TOWN OF DURHAM
8 NEWMARKET RD
DURHAM, NH 03824-2898
603/868-8064 603/868-8065
FAX 603/868-8033
www.ci.durham.nh.us

Town Planner's Review
Wednesday, February 10, 2016

- X. **Public Hearing - Mill Plaza Redevelopment – 7 Mill Road.** Design Review (preliminary application) for a site plan and conditional use for the redevelopment of this 10-acre site. The project involves demolition of rear commercial building, construction of four new buildings and an addition onto the existing Hannaford Building, addition of new commercial space in three buildings on the front/Mill Road side of the project, addition of new residential units on the upper floors of four buildings, garage parking on the first/first and second floor(s) of two buildings in the rear, new parking areas, several open space/seating areas, and other site changes. Colonial Durham Associates, LP, property owner; Joe Persechino, Tighe & Bond, engineer; Lisa DeStefano and Adam Wagner, DeStefano Architects, architect. Central Business District. Map 5, Lot 1-1. Recommended action: Discussion and continuation to February 24. Determine whether to keep public hearing open.

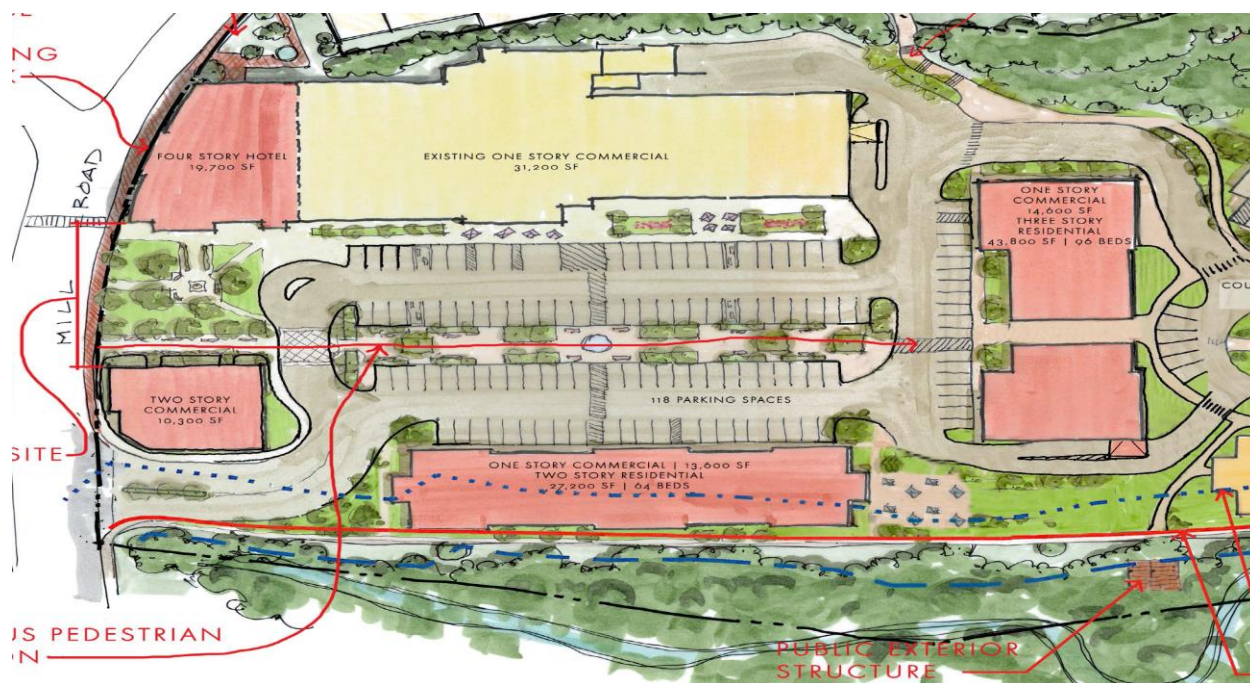
- 35) Earlier plan submittal. This plan below, the prior iteration, was submitted in January 2015. I think this plan is significantly superior to the current plan in that the buildings are better spaced, there is more parking, there is a more appealing entrance to the commercial area, and there is a terrific pedestrian promenade in the middle. The main concern with this plan is whether the curved entrance could accommodate traffic satisfactorily as there could be stacking issues at Mill Road. This design, should be reconsidered. This might place Building C within the wetland buffer (rather than the road) and only nonresidential buildings are allowed there by conditional use.
